SUNSET VILLAGE FILING 4 - DRAINAGE
EL PASO COUNTY, COLORADO

CONSTRUCTION DRAWINGS
POND 2

SUNSET VILLAGE
FILING NO. 4

OUTLET STRUCTURE DETAILS

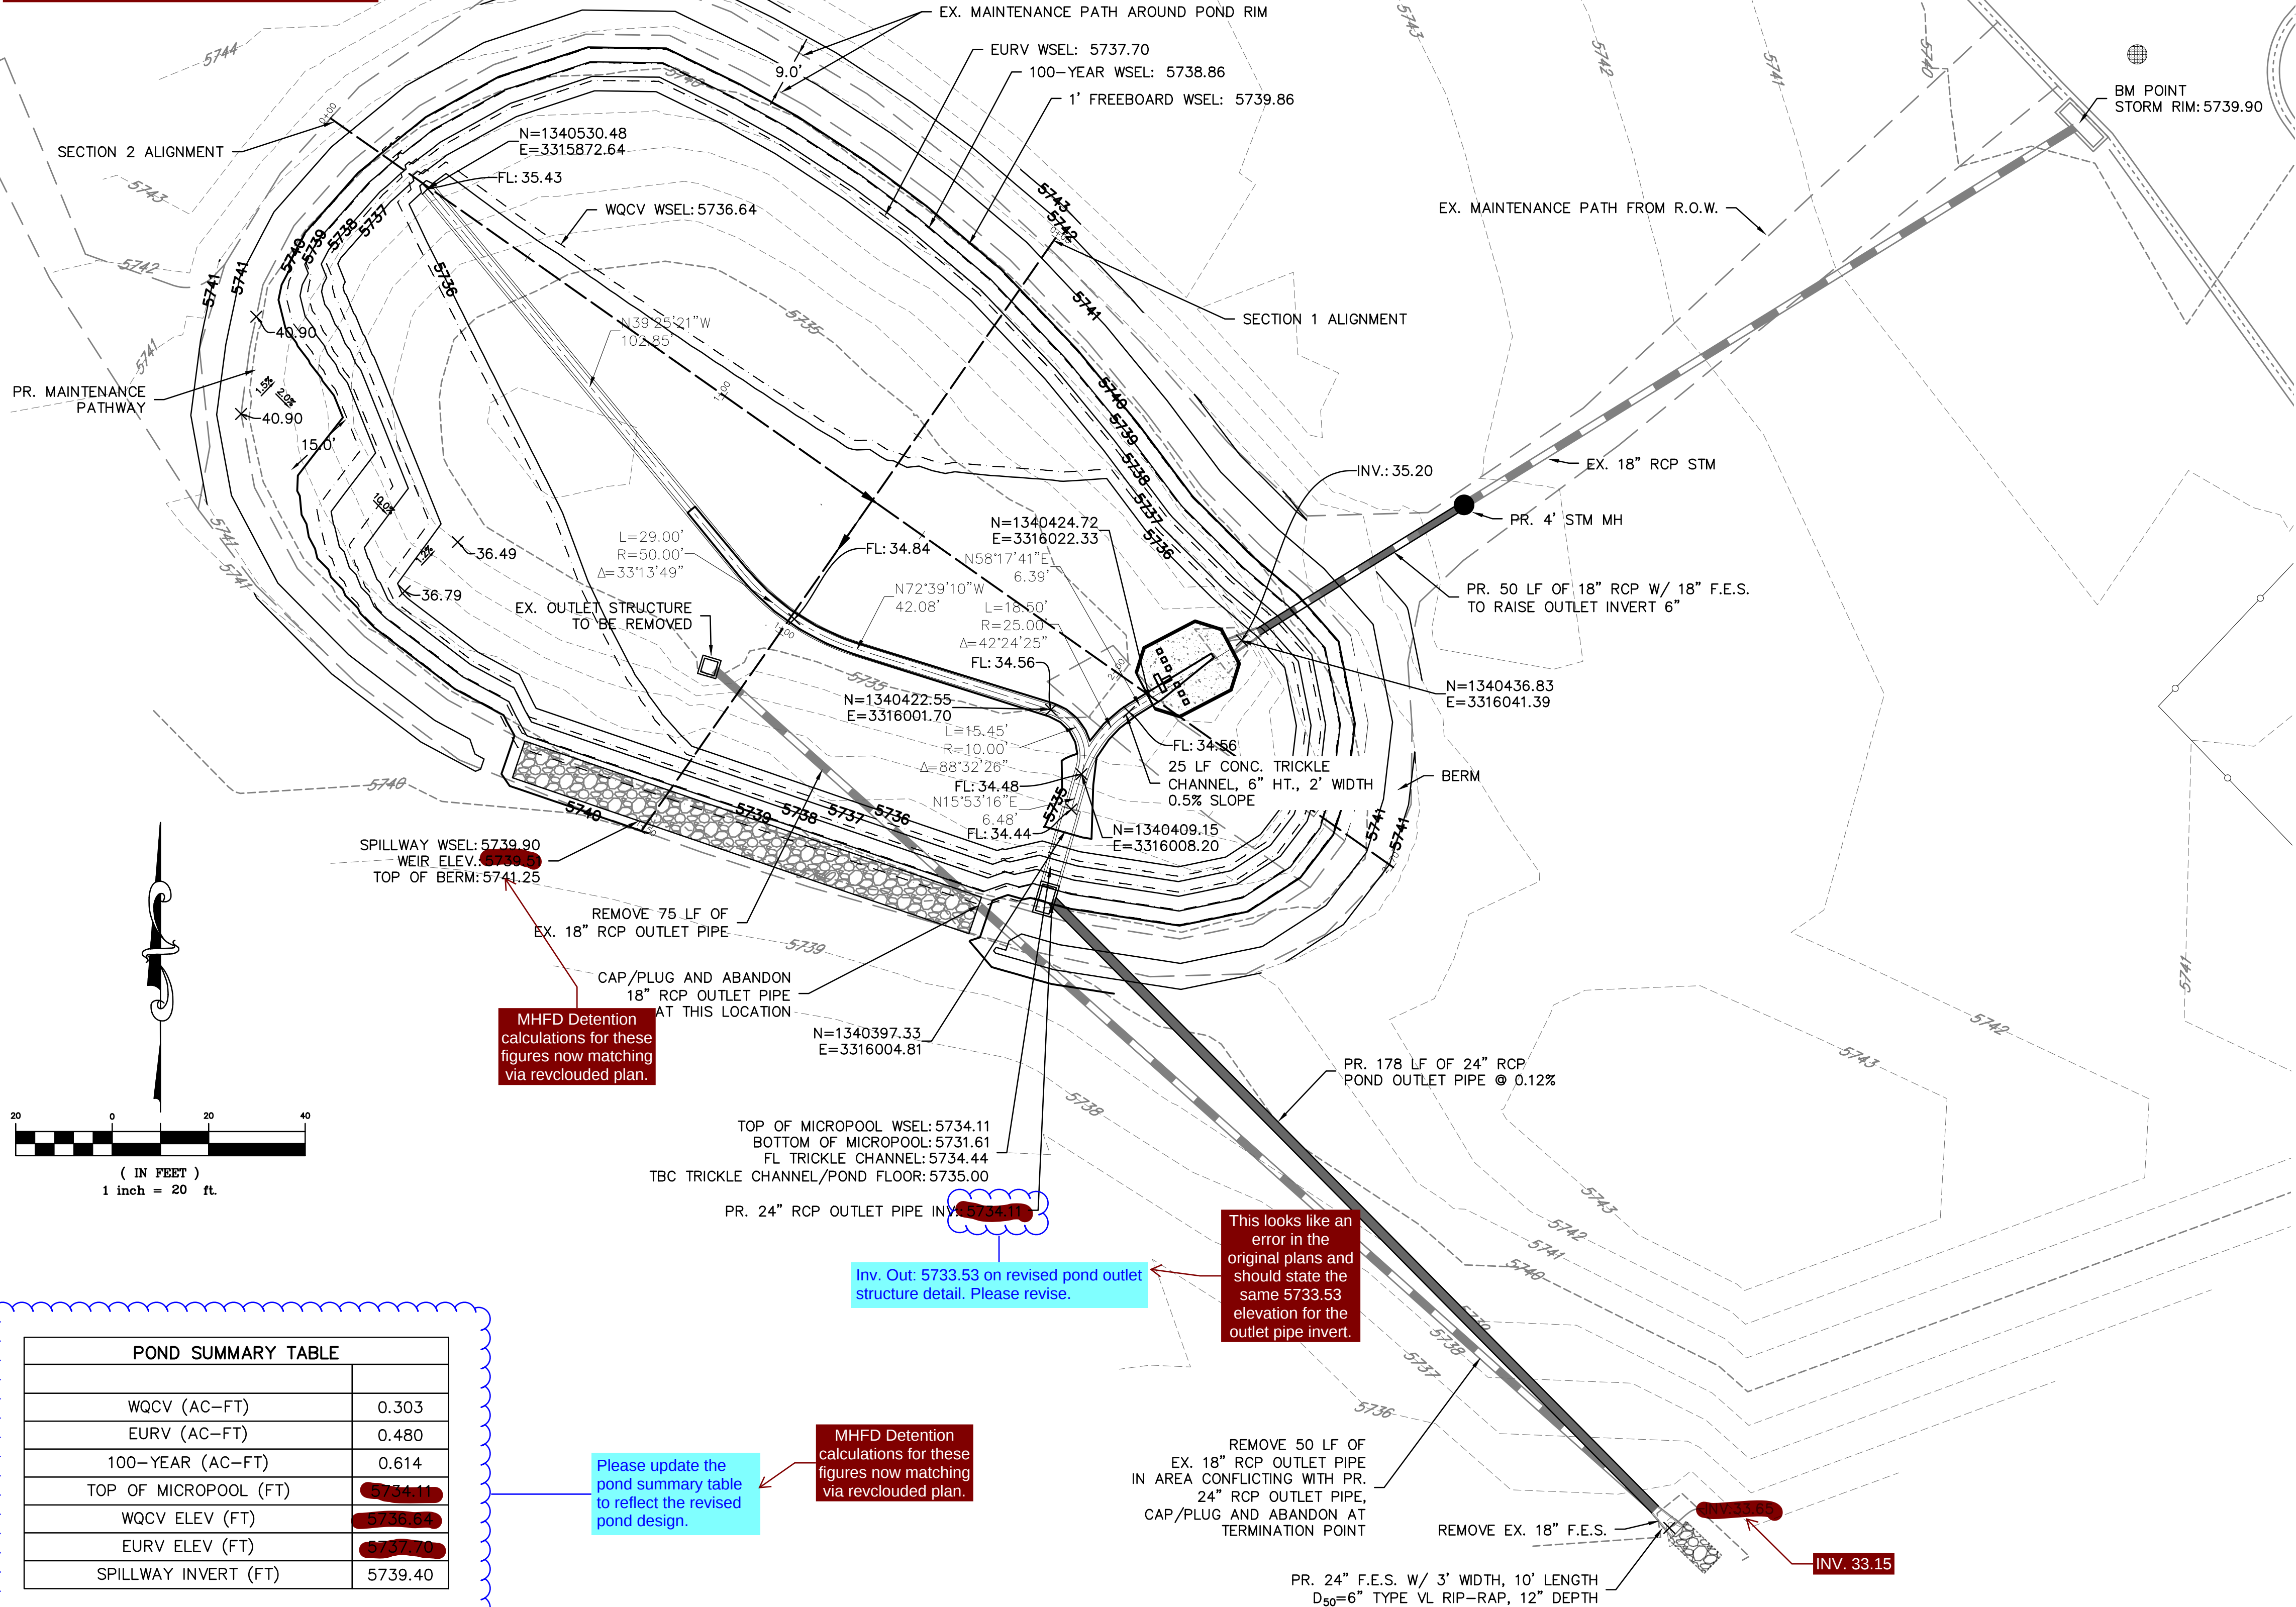
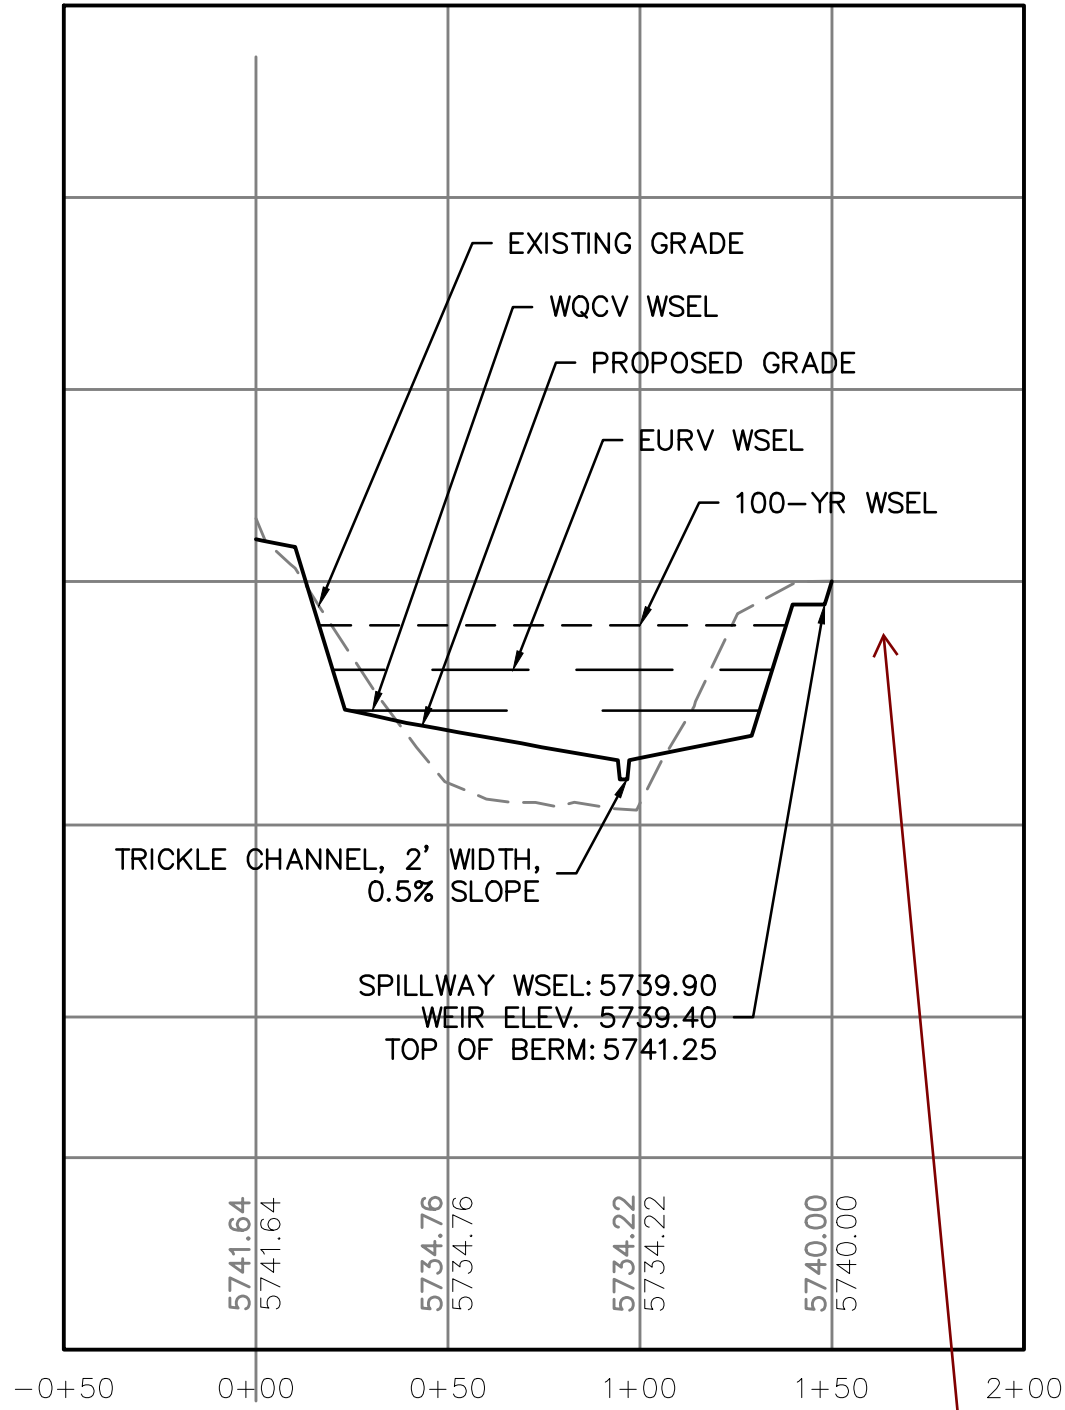
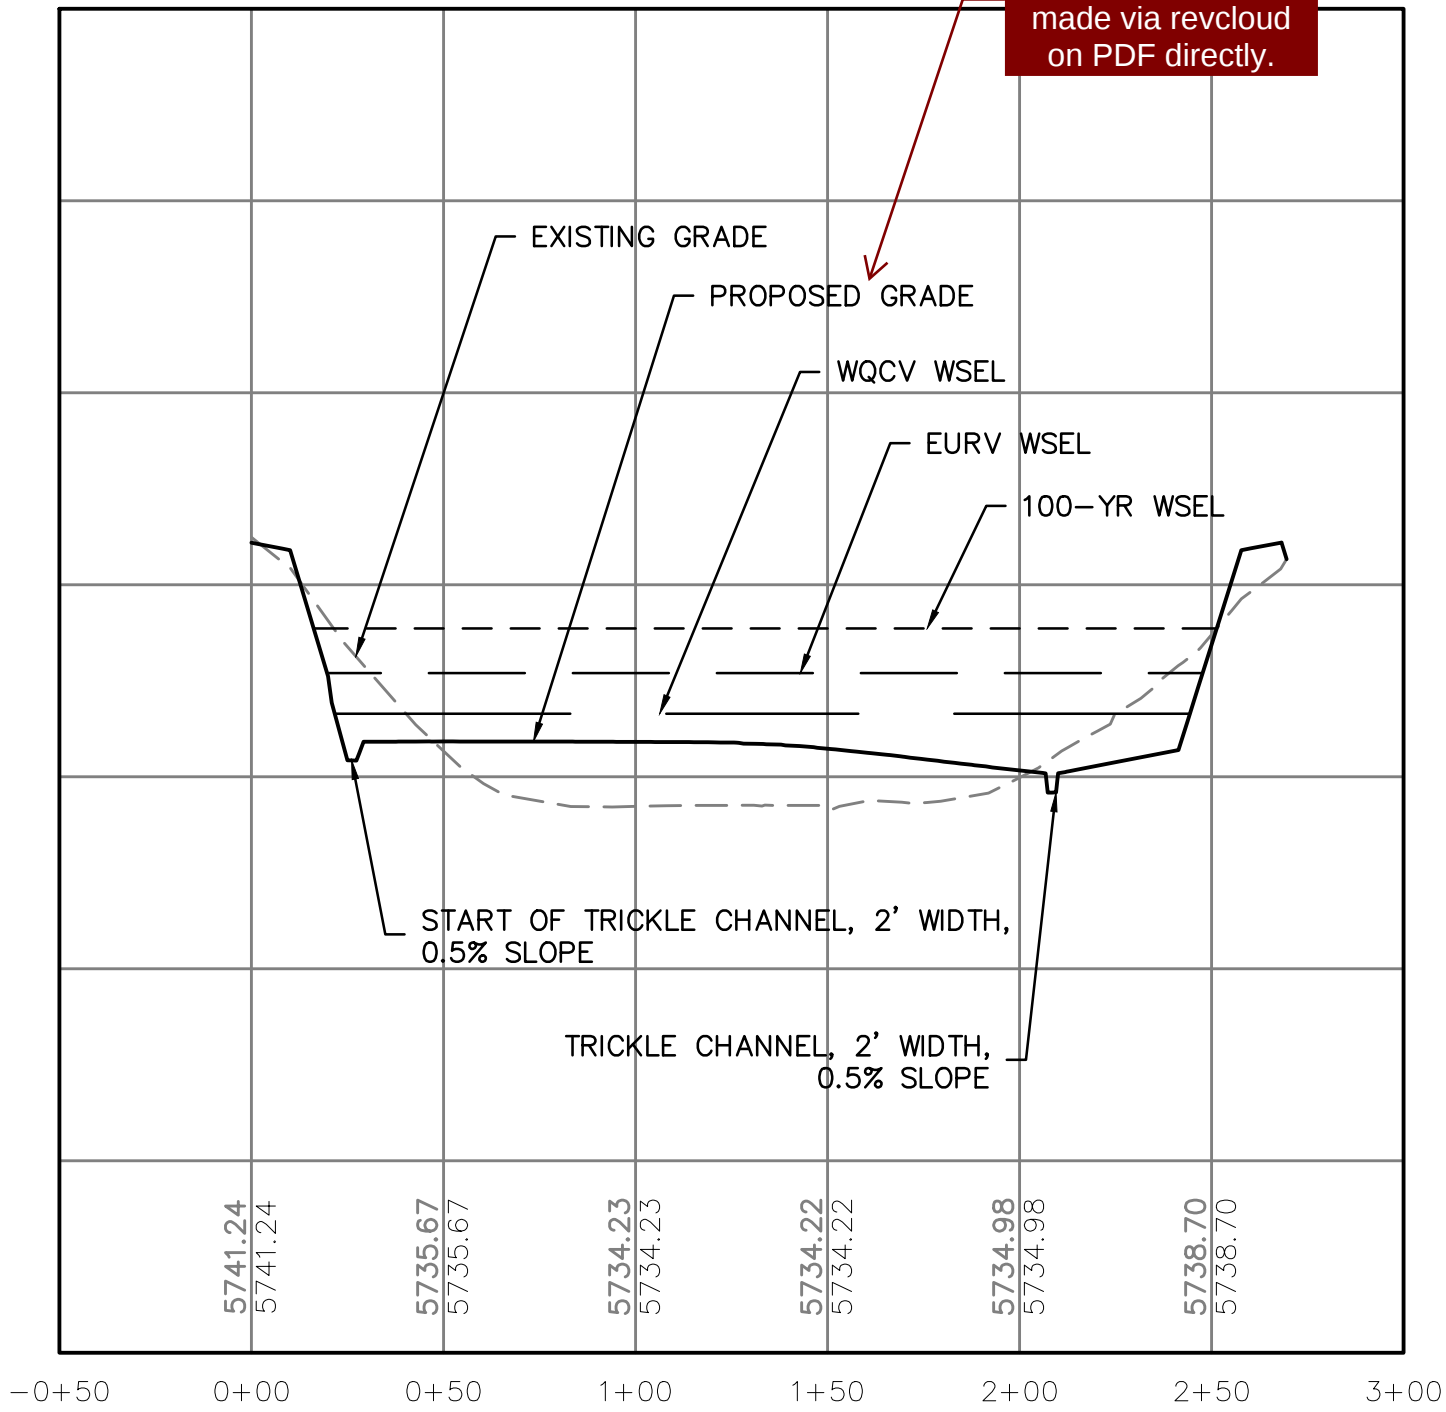
Please update the Pond 2 plan to be consistent with the revised pond outlet structure and forebay details shown on Sheets 20-22. Several elevations on the current Pond 2 sheet—including top of micropool, WQCV WSEL, EURV WSEL, and 100-year WSEL—do not match the updated design information.

Please note that ELX does not have access to previous CAD files from original approved CDR plans. Any revisions and changes required on this plan sheet are directly done via PDF, consistent with the revisions in the last CDR application for the subdivision.
